**RE: 2015SYE103 DA - STAGED DEVELOPMENT AT JOHN COLET SCHOOL - RESPONSE TO DRAFT CONDITIONS FOR DA2015-0558**

**RESPONSE TO COUNCILS JRPP ASSESSMENT REPORT OF  
JOHN COLET SCHOOL  
AT 6 WYATT AVENUE, BELROSE**

Figure 1 Aerial view of the interface between JCS and Wyatt Reserve, the break in the fence used by students to access the reserve circled in red and the reserve toilets circled in blue (Source: Google maps)

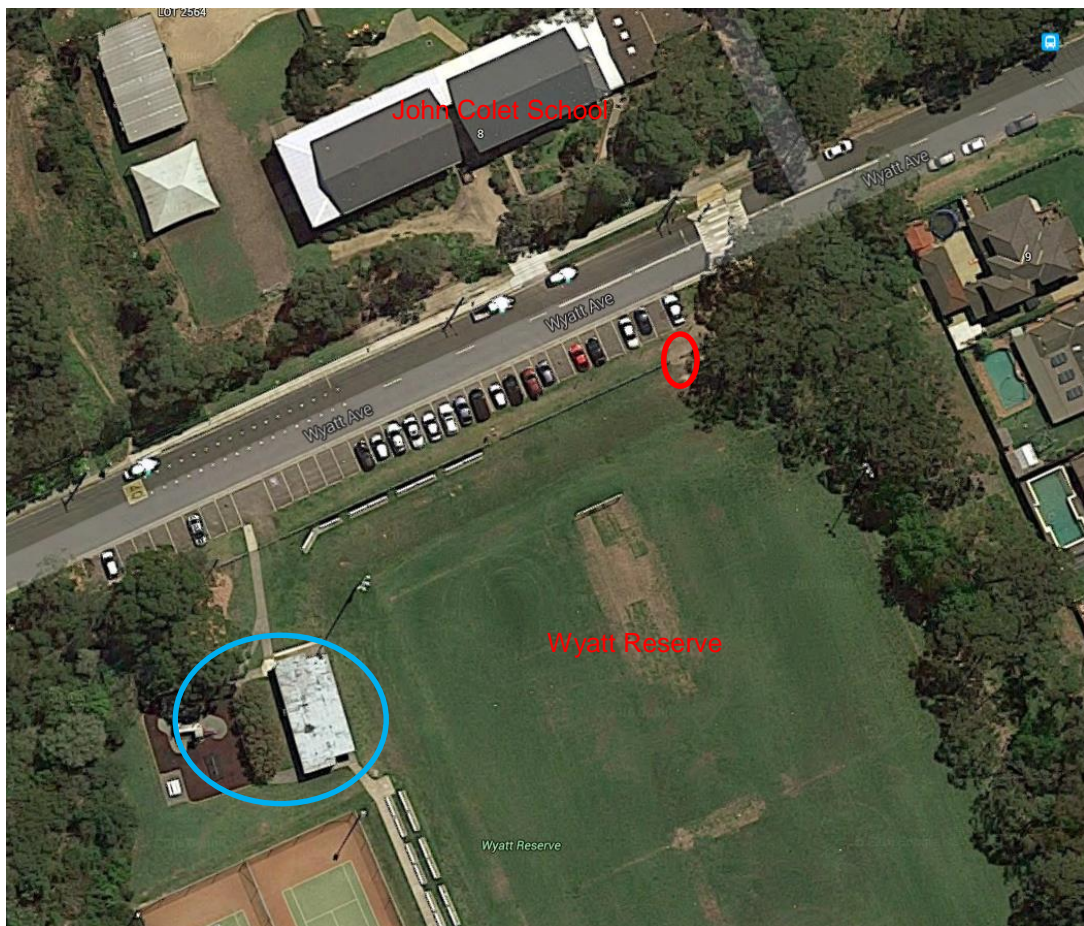
*\* The path of travel taken by the staff and students at JCS is directly from the crossing to the break in the fence as shown in the figure below and not a path of travel for the full length of the frontage of the reserve to the toilets;*

On the basis of the above, we request that Condition 22 be deleted.

**ANNEXURE A: SWEEP PATHS (SHEET 1 OF 3)**

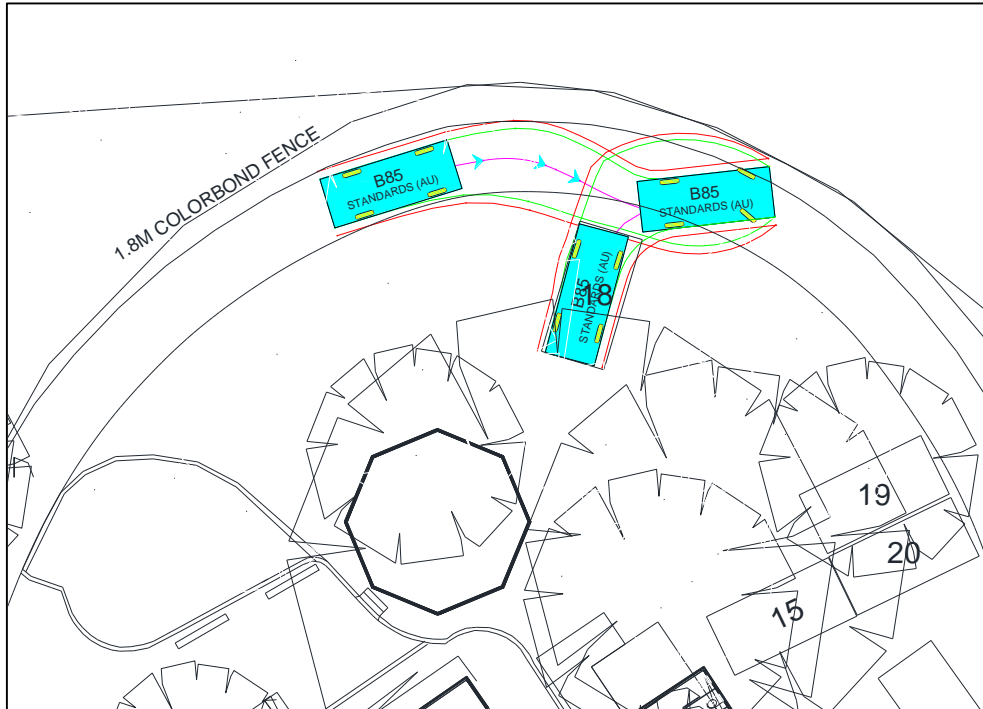
Condition 6 on page 37 requires "*re design of vehicle spaces 18, 19 and 20 to facilitate adequate vehicular manoeuvring movements consistent with relevant Australian Standards.*" AS2890.1:2004 Appendix B, B4.8 states that "*...recognizes that such developments will have low turnover and users generally prepared to accept some inconvenience when entering or leaving the parking space....will need to make a 3 point turn if the manoeuvring space is the minimal allowable. Some very large vehicles may need to make a 5 point turn.*"

The swept path testing, provided in **Annexure A** (as previously supplied to Council in our letter dated 25<sup>th</sup> September 2015) does not exceed 5 manoeuvres in total, thus being within the AS2890 recommendation for Use Class 1A (which includes employee parking). Whilst manoeuvring into and out of some car parking bays goes beyond the compacted area of the surface road, these areas are generally described as low level grasses and vegetation. If necessary, localised widening of the loop road could be provided where necessary.

It is therefore recommended that Condition 6(d) be deleted.
